Determination 2017/044

Regarding the refusal to issue a code compliance certificate for a 14-year-old house at 74 to 76 Voyager Drive, Gulf Harbour, Auckland

Figure 2: The panel cladding

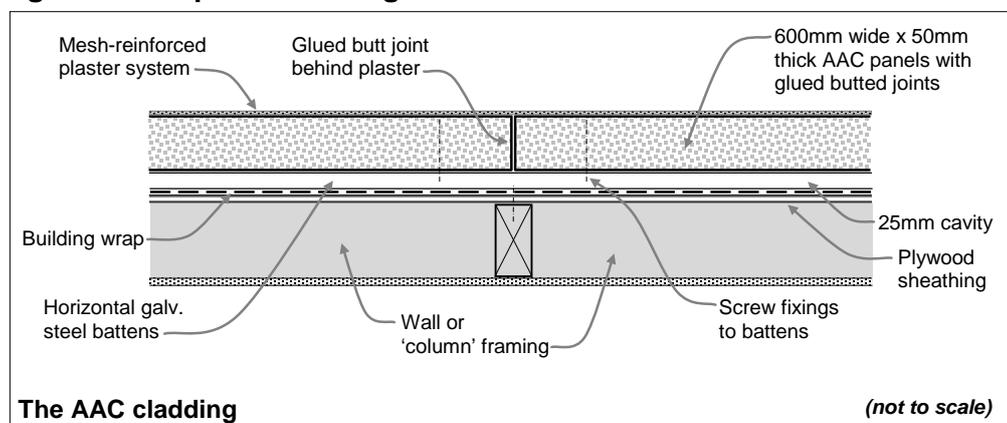
Areas of concern in section 95A refusal, (refer paragraph 3.3.2)	Expert's comments	Compliance	Refer para.
7 Surface water eroding driveway	<ul style="list-style-type: none"> Some cracks in driveway concrete slab Slight horizontal settlement adjacent to cesspit but nowhere else No signs of structural settlement at junction with house, with tile sealant joint intact and undisturbed Nothing to suggest ongoing erosion or risk of failure (Driveway slab independent of house) (The engineer reported on the driveway in 2016) 	Adequate (B1,E1, E2, B2)	3.5.2
8 Unsealed wiring penetrations for light fittings	<ul style="list-style-type: none"> Some light fittings on seaward side corroded No adjacent moisture levels elevated Cladding installed over cavity so any sealant failure unlikely to lead to moisture entry into framing (Wiring to courtyard masonry columns now sealed) 	Adequate given ongoing maintenance (E2, B2)	Fig.2

Figure 3: Framed parapet 'beam'

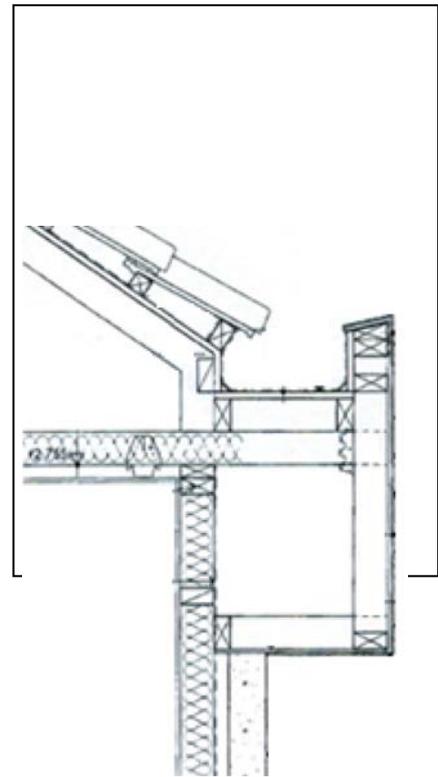
2.5.5 Taking account of the expert's observations; I note that although similar, the as-built parapet detail differs from that shown in Figure 3, in that:

- liquid-applied membrane is used in lieu of butyl rubber membrane⁸
- the textured fibre-cement extends down to form a 20mm drip edge at the soffit
- the lower decorative band is identical in thickness to the upper band.

3	Parapet cladding cracks	<ul style="list-style-type: none"> No cracks evident during inspection 2016 membrane refurbishment included the LAM parapet capping (and repainting of cladding would have included repairs to any joint cracking) (Vertical control joints appear to be installed) (Parapet framing is largely beyond the line of AAC panels) No evidence of failure to perform over the past 14 years 	Adequate given ongoing maintenance (E2, B2)	5.7.1 2.4 2.4.3 Fig.3 3.6
4	AAC cladding/soffit junctions	<ul style="list-style-type: none"> Protected by parapet 'beam' overhangs and drip edges No significant risk of moisture penetration (Parapet framing is largely beyond the line of AAC panels) No evidence of failure to perform over past 14 years 	Adequate (E2, B2)	2.4 2.4.3 Fig.3
5	Flat membrane roof areas	<ul style="list-style-type: none"> Recently recoated and in good condition No significant ponding apparent Ceilings inspected – no evidence of failure to perform No evidence of failure to perform over past 14 years 	Adequate given ongoing maintenance (E2, B2)	3.6 5.7.1 Fig.3
